STAFF REPORT
(Preliminary Plat)

CASE NUMBER: SUB 2004-42 – YODER AIRPORT THIRD ADDITION

STAFF REPORT
(Final Plat, Preliminary Plat Approved 4/15/04)

CASE NUMBER: SUB 2004-42 -- YODER AIRPORT THIRD ADDITION

VICINITY MAP

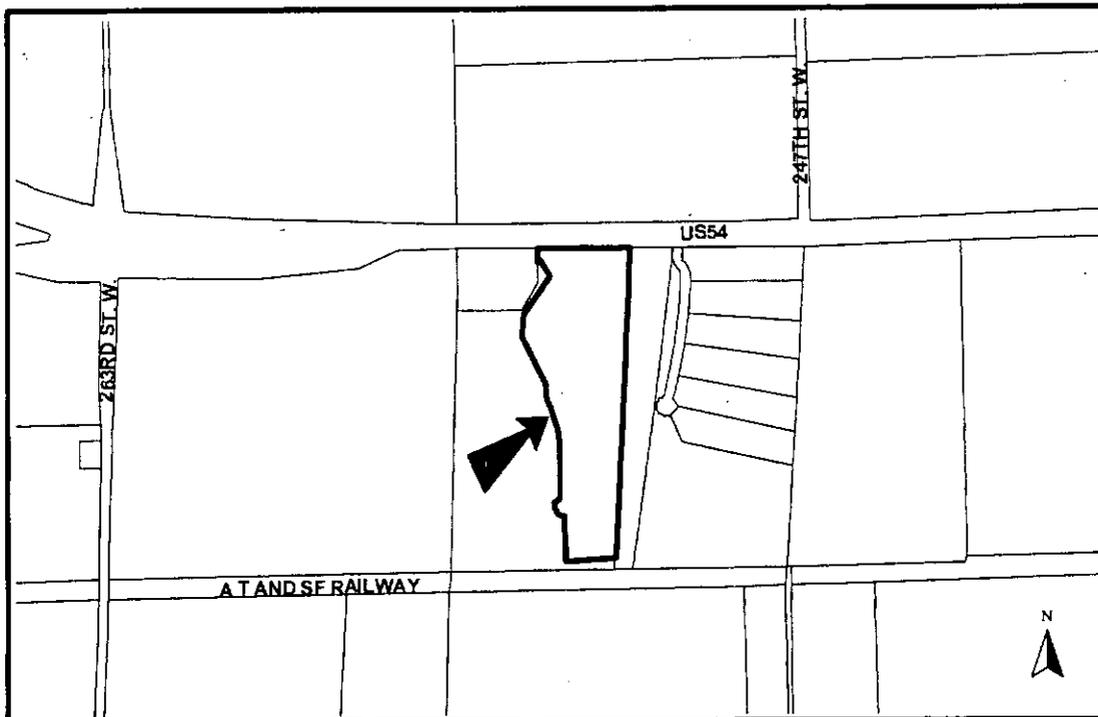
- D. The benchmark needs an elevation.
- E. The strip along the east and south sides of Lots 7 & 8 should be included within the plat.
- F. The vicinity map needs to be corrected.
